**66106A-07**

**S E R V I C E N O T E**

**66106A DC Power Supply**

**The instrument will not communicate or will not complete self test.**

**Diagram A:** ROM not fully inserted

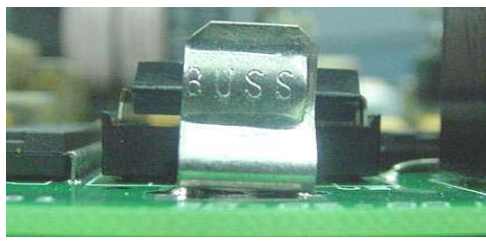
The Programmed ROM P/N 5080-2529 (Circuit Reference “U2”) See [Figure 1](#).below for the location of “U2”. When the ROM “U2” is not inserted correctly See [Diagram “A”](#) for details, the instrument may exhibit the following faults:

These faults could also occur if the ROM or the socket is intermittent due to dirty or contaminated pins.

1. The instrument will not turn on
2. All of the segments on the Front Panel display are not light.
3. The instrument will fail self test or will not boot-up.
4. The instrument will not communicate & can not be calibrated.

The ROM “U2” should be removed from the socket. (See [Figure 1](#)). The socket and the ROM should be inspected for contamination or other defects. The ROM is a ceramic part and can be damaged or broken if too much force is applied when reinstalled. [Diagram “B”](#) shows the ROM “U2” inserted correctly.
